ADDENDUM NO. 1

Date of Addendum: October 13, 2015

PROJECT NAME: Rehabilitation of Distribution Pumps, Motors, Valves, Piping and  
Pump Station Buildings at Various Facilities - Package B

PROJECT NO: WBS No. S-001000-0046-4

WH#3-E-6

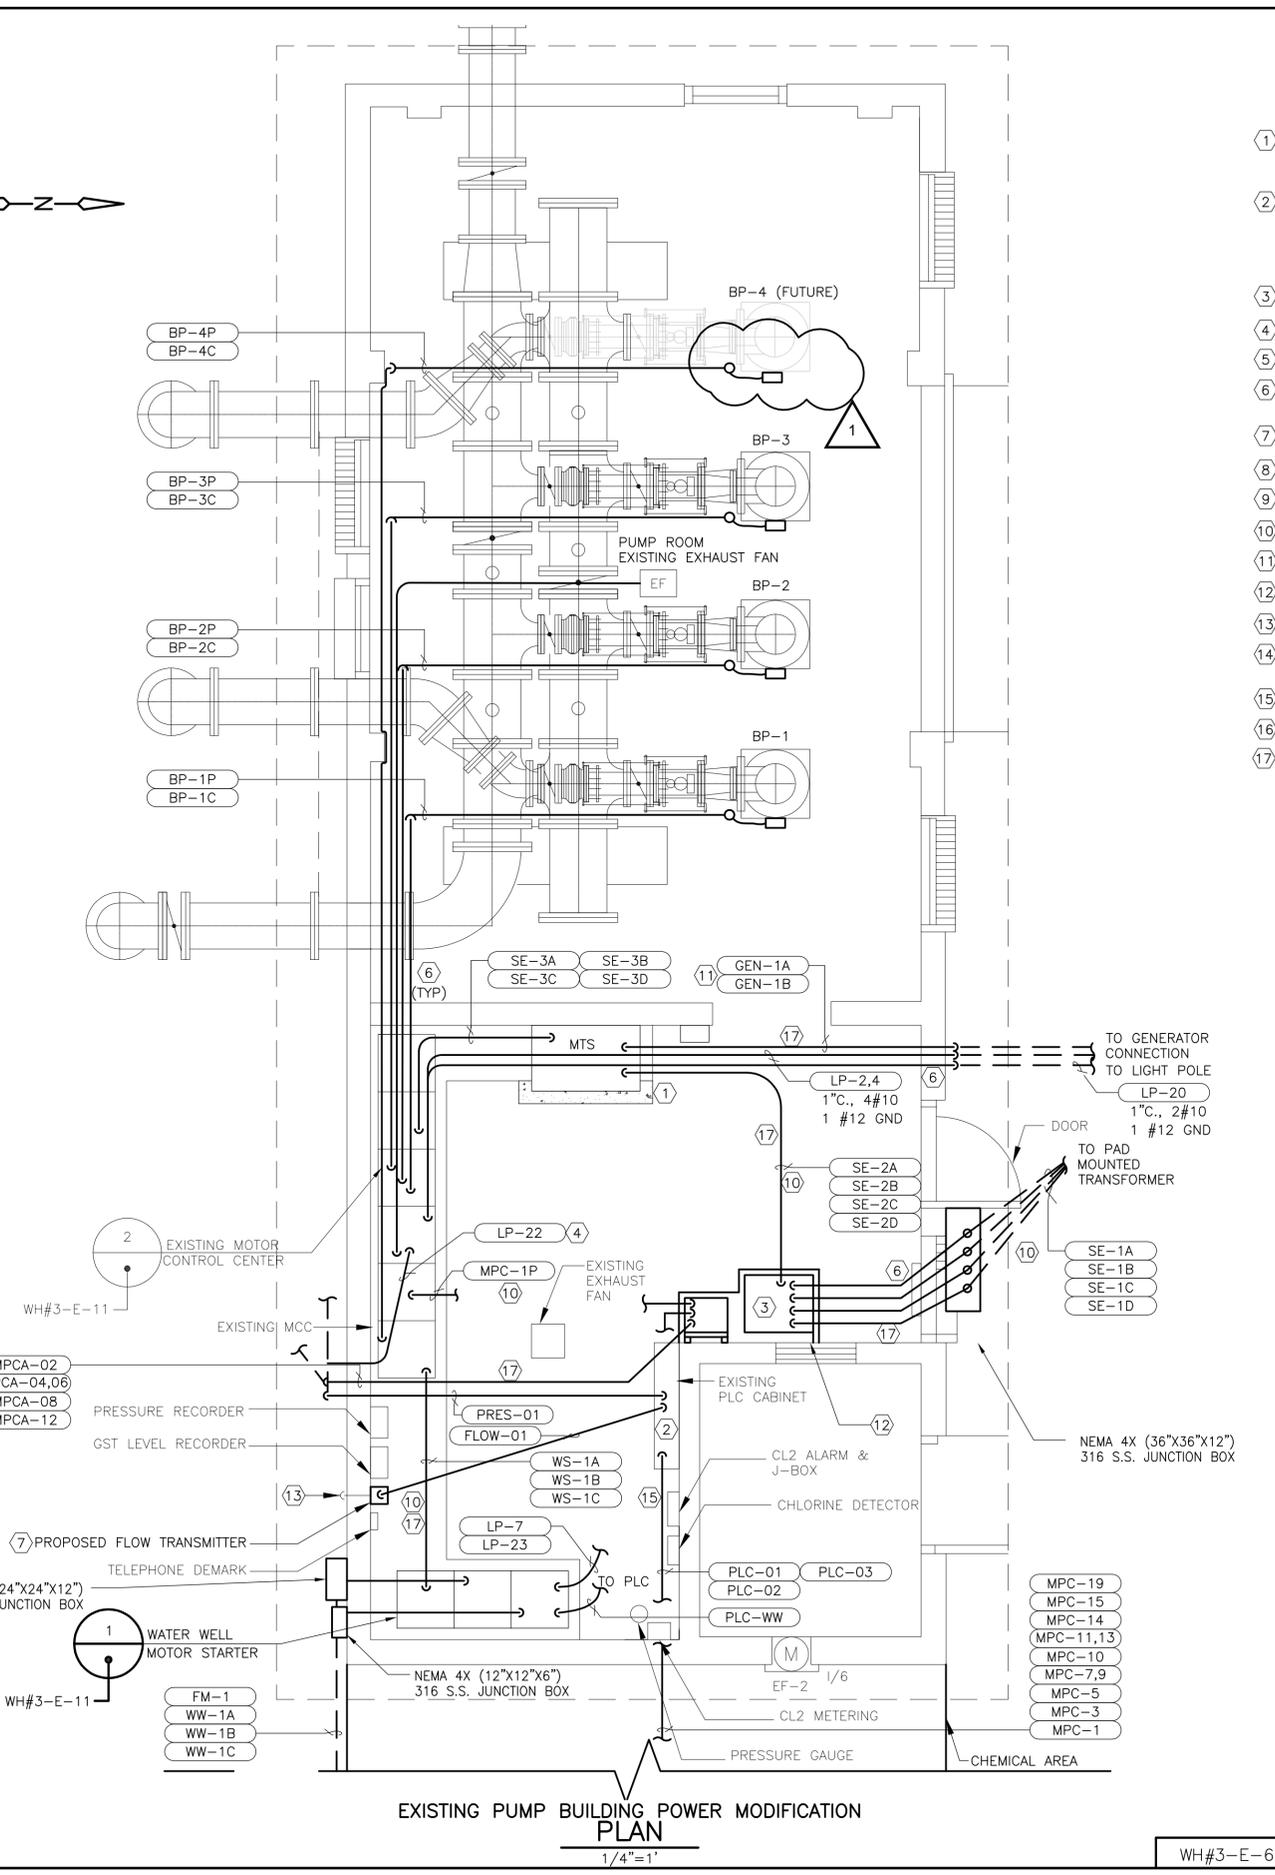
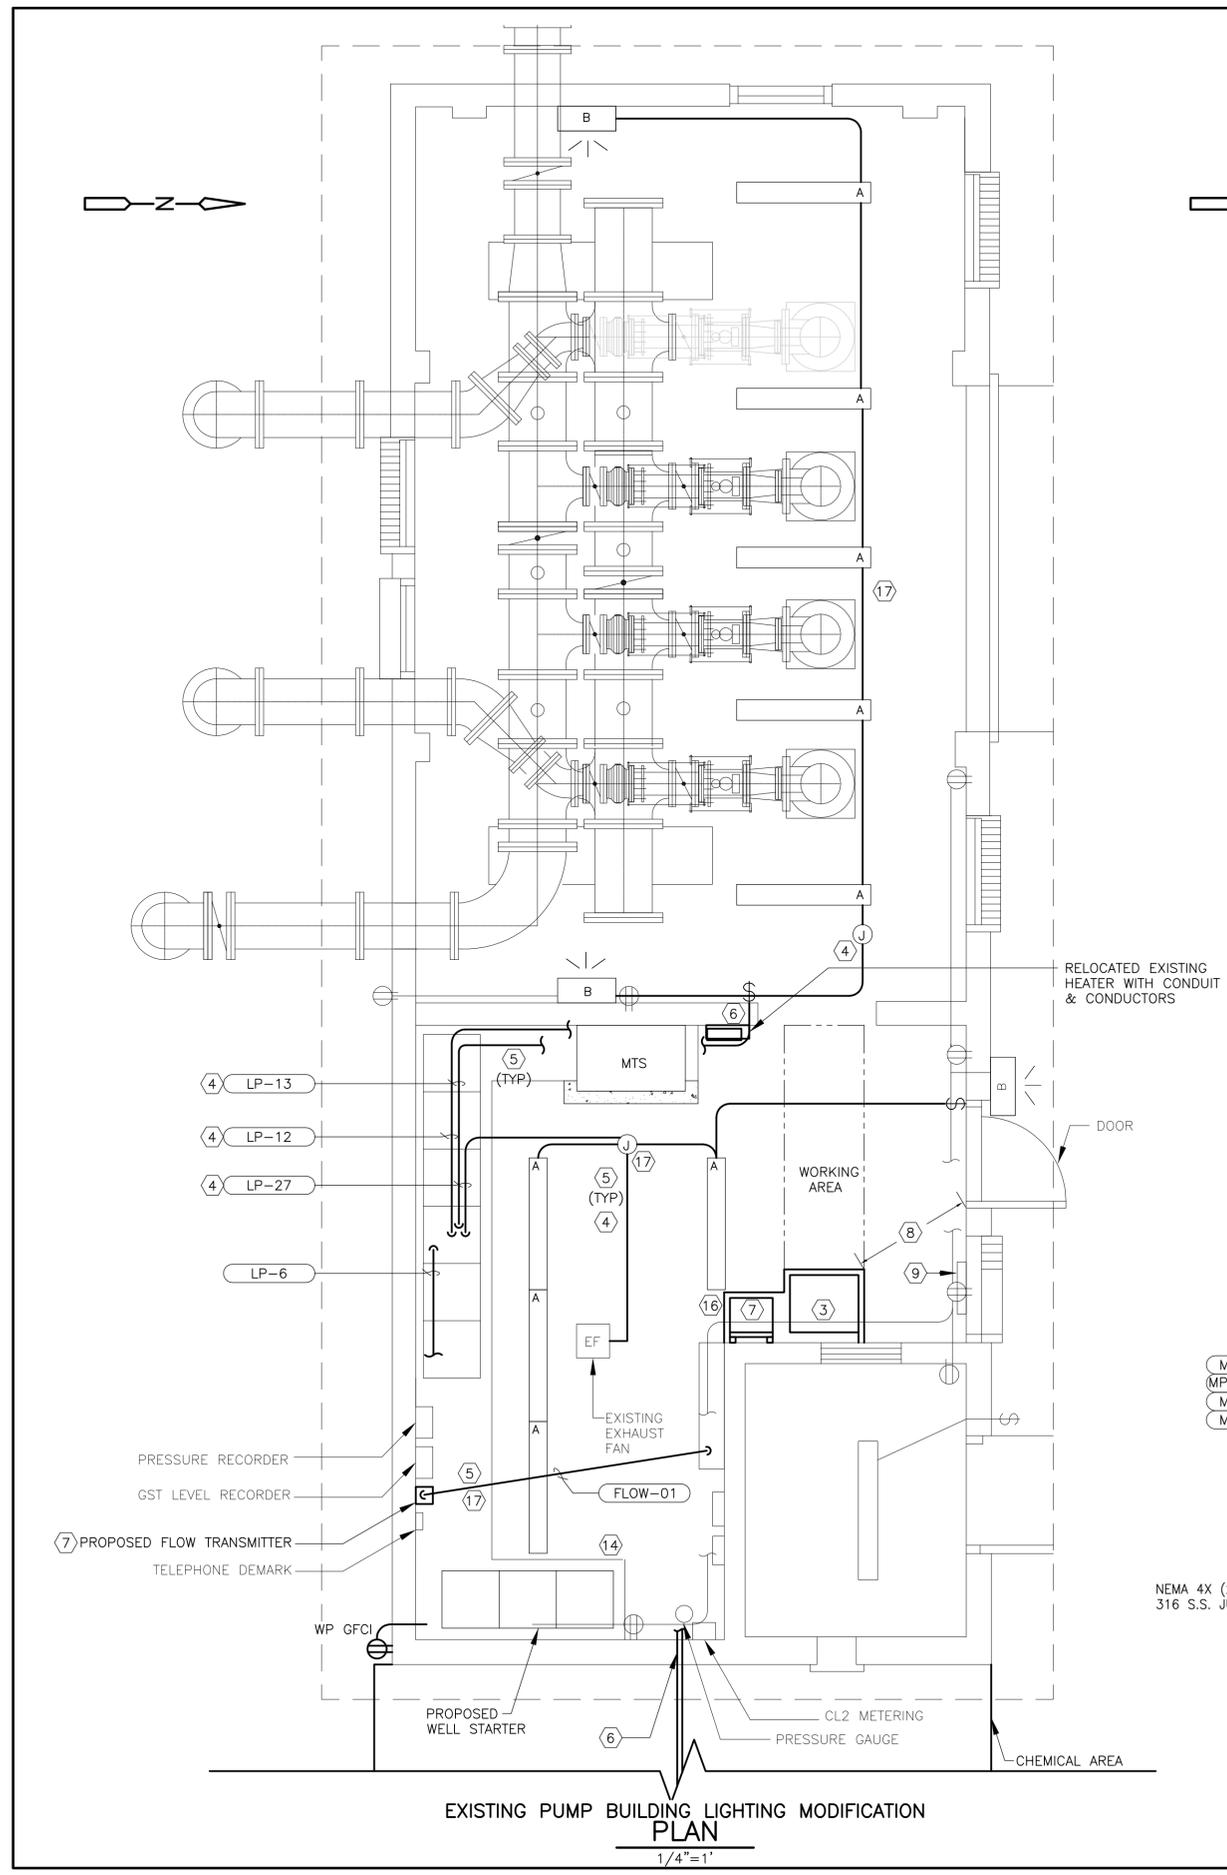
12. Delete Sheet 61 (WH#3-E-6), Proposed Pump Building Lighting & Power Plan, and replace with revised Sheet 61 (WH#3-E-6).
13. Delete Sheet 78 (PTC-M-2), Booster Pumps and Piping Proposed Plan, and replace with revised Sheet 78 (PTC-M-2).

WBS NUMBER	S-001000-0046-4
DRAWING SCALE	3/8"=1'-0"
CITY OF HOUSTON PM	RAJINDER SINGH
PTC-M-3	SHEET No. 79 OF 139

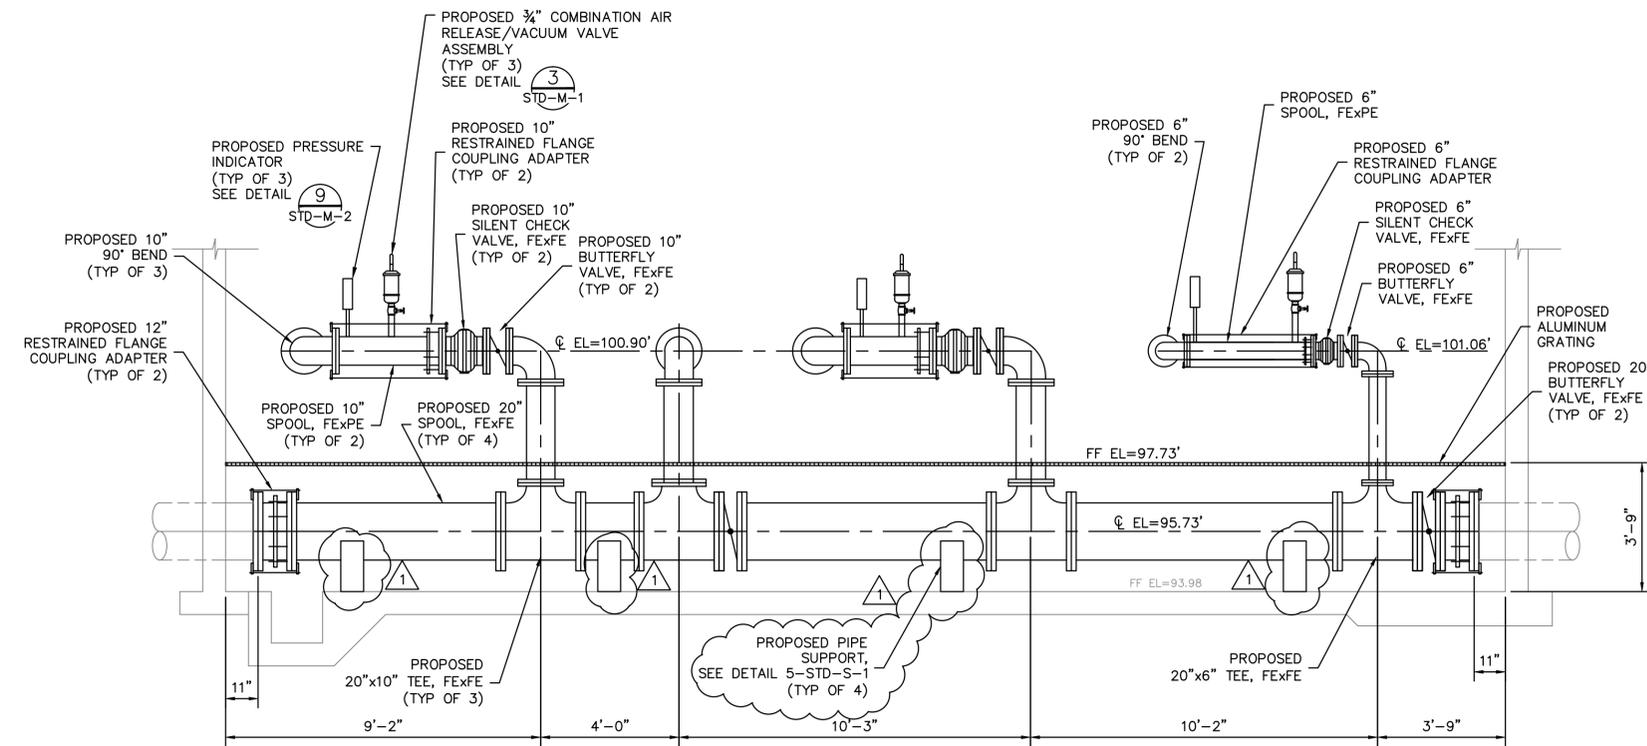
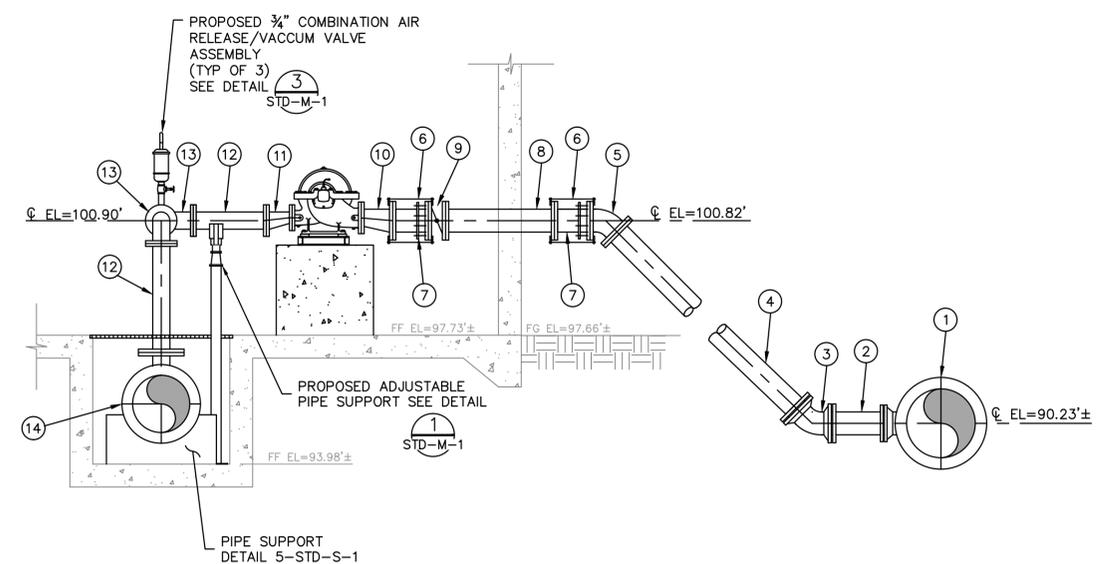
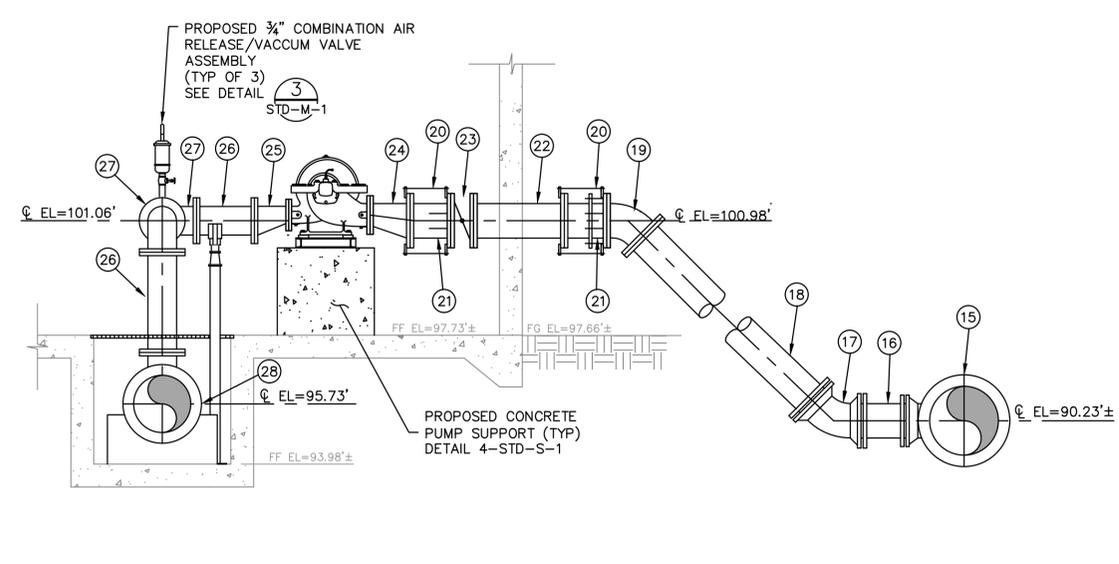
14. Delete Sheet 79 (PTC-M-3), Booster Pumps and Piping Proposed Sections, and replace with revised Sheet 79 (PTC-M-3).
15. Delete Sheet 107 (SH#1-C-2), Proposed Site Plan, and replace with revised Sheet 107 (SH#1-C-2).

WBS NUMBER	S-001000-0046-4
DRAWING SCALE	1/4"=1'-0"
CITY OF HOUSTON PM	RAJINDER SINGH
SH#1-M-1	SHEET No. 112 OF 139

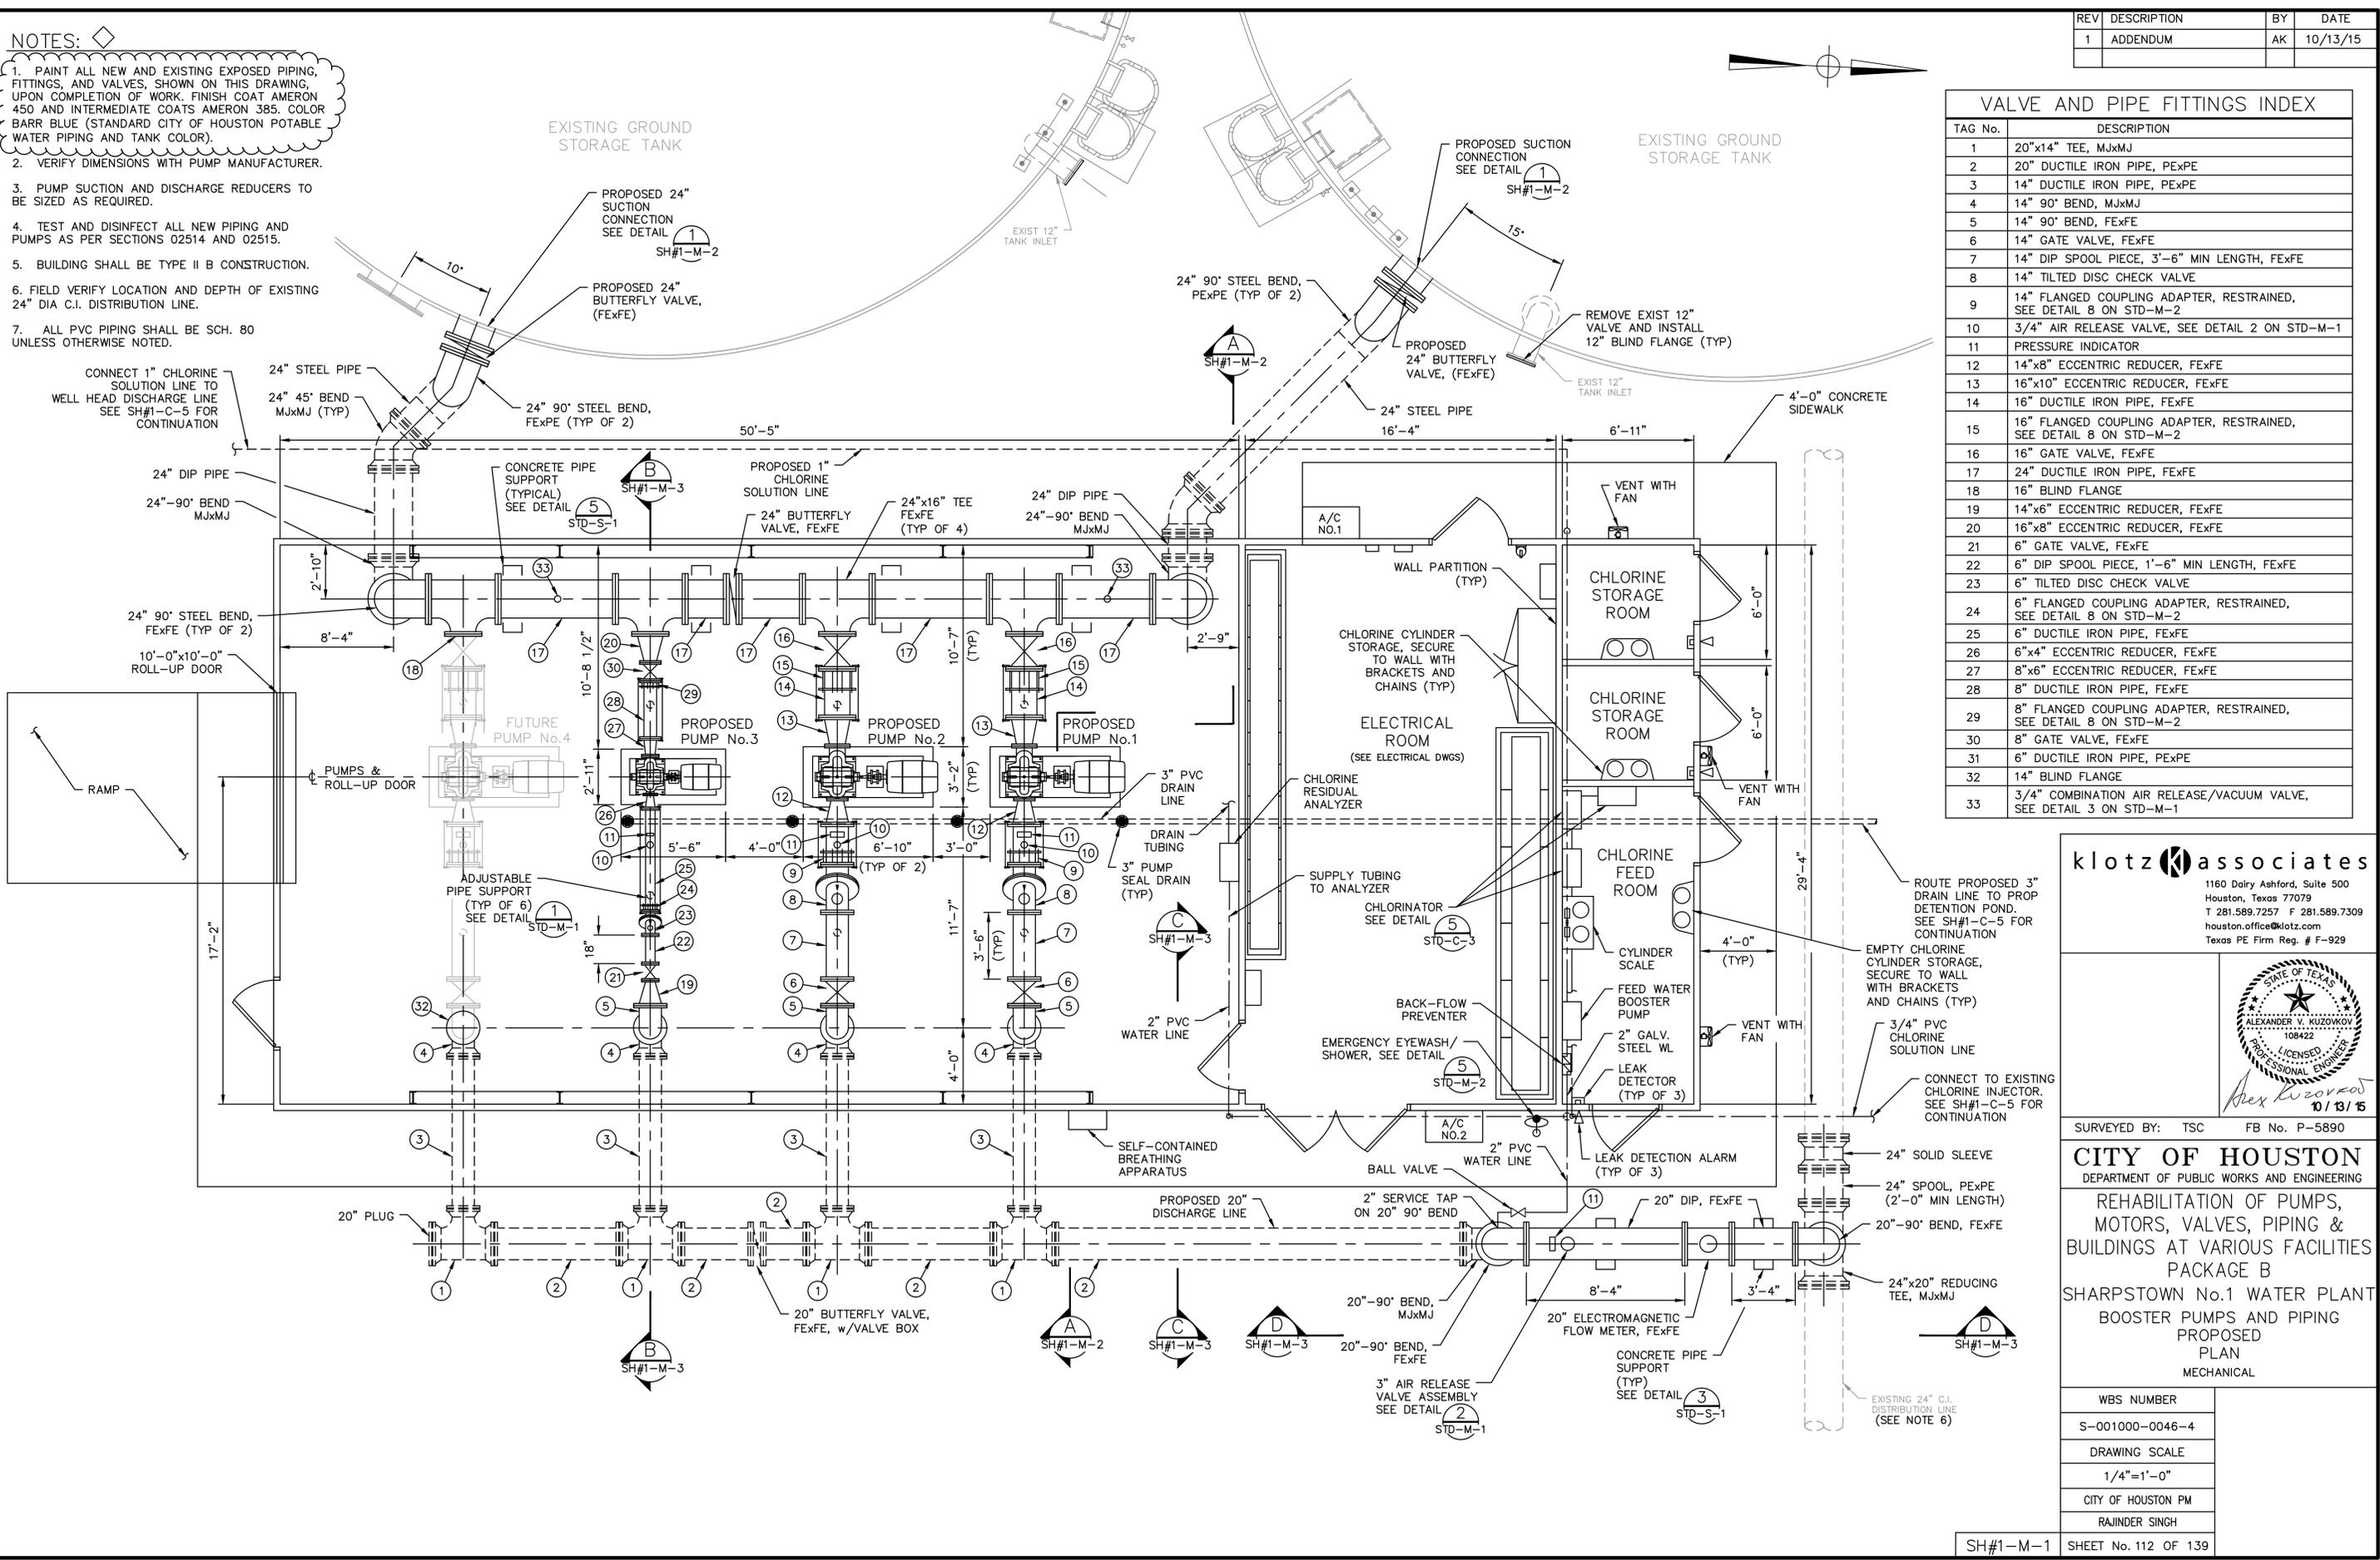
16. Delete Sheet 112 (SH#1-M-1), Booster Pumps and Piping Demolition Plan, and replace with revised Sheet 112 (SH#1-M-1).
17. Delete Sheet 117 (SH#1-H-1), Building HVAC Plan, and replace with revised Sheet 117 (SH#1-H-1).
